Tiva™ C Series TM4C129x Microcontrollers Silicon Revisions 1, 2, and 3

1 Introduction

This document describes known exceptions to the functional specifications for all of the Tiva™ C Series TM4C129x microcontrollers. Note that some features are not available on all devices in the series, so not all errata may apply to your device. See your device-specific data sheet for more details.

Figure 2. RC Circuit

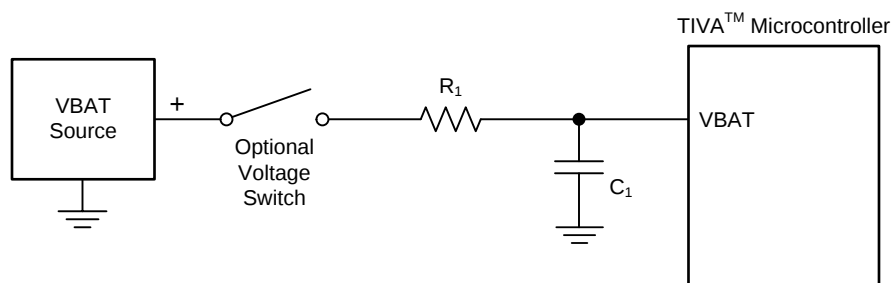
V_{BAT} Supply pin may be Damaged if the pin Voltage Ramps Faster Than $0.7 \text{ V}/\mu\text{s}$

Description The V_{BAT} supply pin may be damaged if the pin voltage ramps faster than $0.7 \text{ V}/\mu\text{s}$. Fast V_{BAT} ramps are a concern when a battery is being connected or the V_{BAT} supply is hard switched.

Workaround(s) An RC circuit as shown should be added to the V_{BAT} pin to prevent the damage. The R_1 and C_1 should be placed close to the microcontroller for best protection. In systems that do not require Hibernate when the VDD supply is off, the V_{BAT} pin should be tied to the VDD supply, which typically ramps at a rate slower than $0.7 \text{ V}/\mu\text{s}$. The R_1 and C_1 components are not required for a V_{BAT} supply ramp less than $0.7 \text{ V}/\mu\text{s}$.

ETH#04 ***SMI Electrical Section Update (1)***
Revision(s) Affected: 1, 2, and 3.

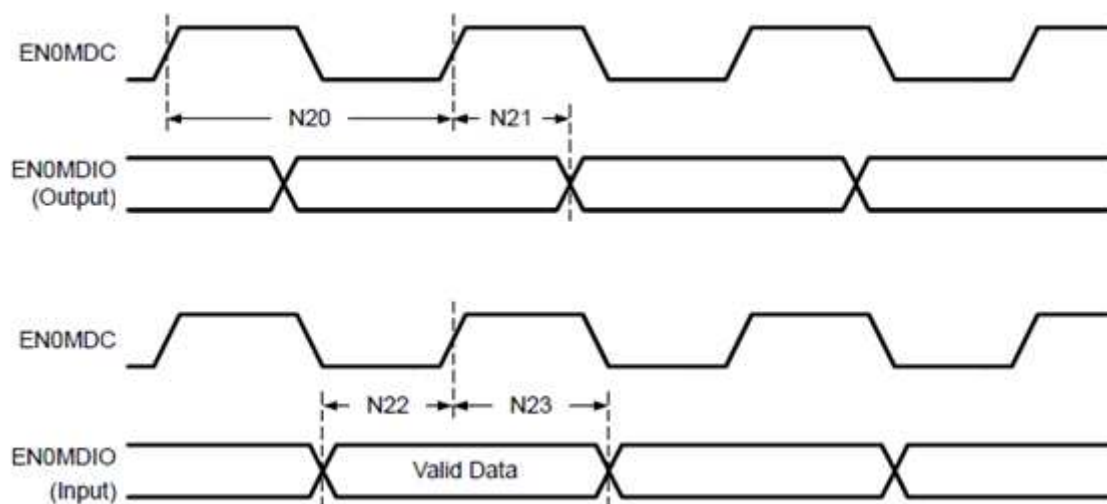
Description: The following table in the Electrical Characteristics for Ethernet Controller AC Characteristics for MII Serial Management the table is incorrect for parameters N20 and N21.

Parameter No.	Parameter	Parameter Name	Min	Nom	Max	Unit
N20	F _{MDC}	ENOMDC frequency	-	-	2.5	MHz
N21	T _{MDO_PLY}	ENOMDC to ENOMDIO (output) delay time	0	-	150	ns
N22	T _{MDO_SU}	ENOMDIO (input) to ENOMDC setup time	10	-	-	ns
N23	T _{MDO_HLD}	ENOMDIO (input) to ENOMDC hold time	10	-	-	ns

The MDO Timing = $(1/(2 \cdot F_{mdc})) + 1 \text{ System Clock Period} + 10\text{ns}$

MEM#15 ***Specific Flash Locations in any Sector do not get Erased***
Revision(s) Affected: 1, 2, and 3.

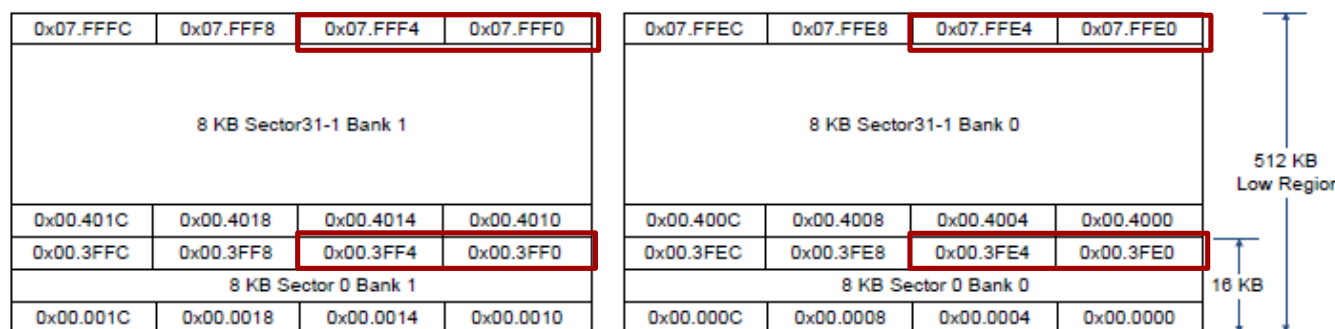
Description: If only one or both of the first two words of the last line of a sector in a bank are programmed, an Erase of entire Sector, Mass Erase of device, or toggle mass erase does not erase the flash back to all 1's. The diagram below shows the affected words in Sector 0 and Sector 31 of the lower 512KB of Flash.

Workaround(s): Program any other word in the Sector-Bank to allow Sector Erase to work.

NOTE: Toggle Mass Erase or Mass Erase will still not work.

Figure 3. VDDA Waveform to Avoid Between V_{POR} min and V_{POR} max

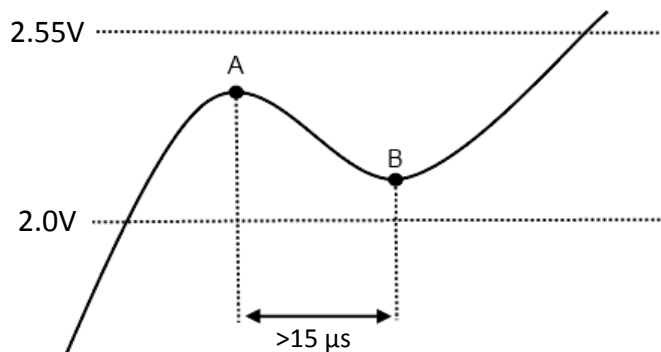
Workaround(s): A monotonic voltage rise of VDDA prevents this issue from occurring; however, a perfect monotonic ramp is difficult to achieve, particularly during LDO inrush. The risk of encountering this issue can be minimized by performing one of the following:

- If the VDD and VDDA pins are connected directly to the same power source, at every possible point A and point B along the VDDA waveform between 2.0 V and 2.55 V, point B must never fall below point A after 15 μ s, as shown in [Figure 3](#).
- Use a separate power supply for VDDA to reduce noise and isolate it from the effects of LDO inrush. At every possible point A and point B along the VDDA waveform between 2.0 V and 2.55 V, point B must never fall below point A after 15 μ s, as shown in [Figure 3](#). The separate power supply will make it easier to avoid this condition.

SYSCTL#22 ***Change to the PLL Clock Divider may Cause System Clock to be out of Specification***

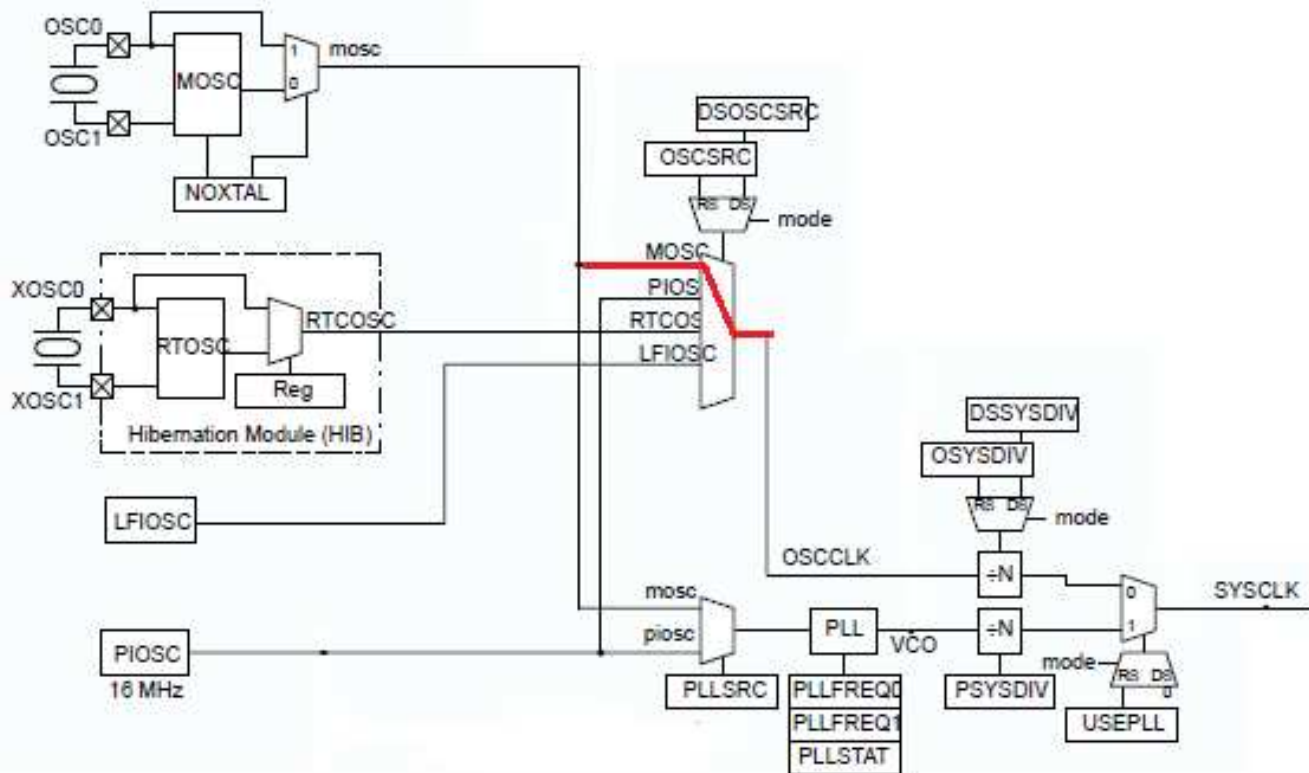
Description: When generating system clock from the PLL, the user programs the system control register bits RSCLKCFG.PSYSDIV to divide the PLL output. This register value may not be loaded into the physical divider causing the system clock to be divided by 2. This condition will cause the system clock to be out of specification.

The issue will be caused if ROM_SysCtlClockFreqSet or SysCtlClockFreqSet API provided in TivaWare 2.1.2 or earlier is used.

Workaround(s): There are two workarounds:

- Update the SysCtlClockFreqSet API as shown in [Appendix 3](#)
- Use the SysCtlClockFreqSet API in flash from TivaWare 2.1.3 release onwards.
